Description of Changes - NUREG-1431 Section 3.04.02

Justification For Deviations - NUREG-1431 Section 3.04.02

3.4 REACTOR COOLANT SYSTEM (RCS)

3.4.2 RCS Minimum Temperature for Criticality.4.2 RCS Minimum Temperature for Criticality

Figure 15.3.1-1/PBNP Units 1 & 2
Heatup Limitations Applicable to
23.6 Effective Full Power Years
(Approximately January 2001)

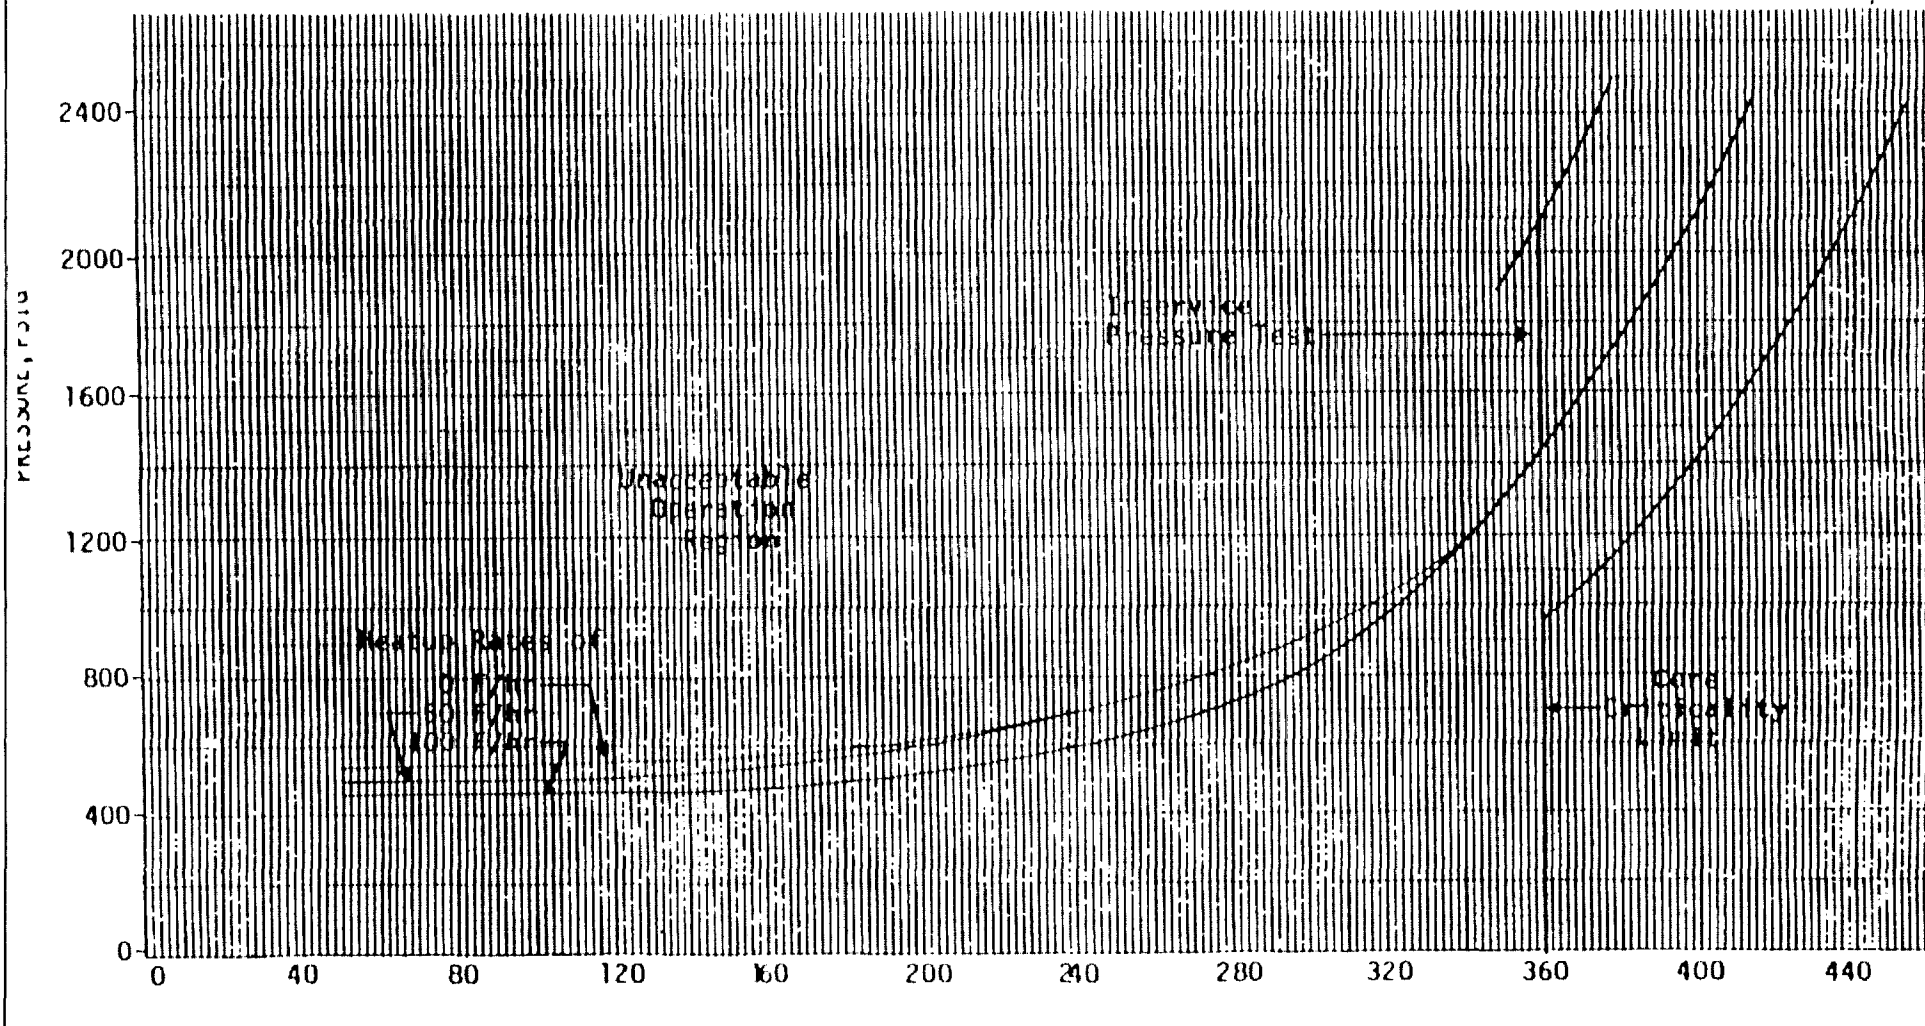
1. The Reactor Coolant System temperature and pressure shall be limited in accordance with the limit lines shown in Figure 15.3.1-1 and 15.3.1-2 during heatup, cooldown, criticality, and inservice leak and hydrostatic testing with:

The heatup and cooldown curves presented in Figure 15.3.1-1 and 15.3.1-2 were calculated based on the above information and the methods of ASME Code Section III (1974 Edition), Appendix G, "Protection Against Nonductile Failure", and are applicable up to the operational exposure indicated on the figures.
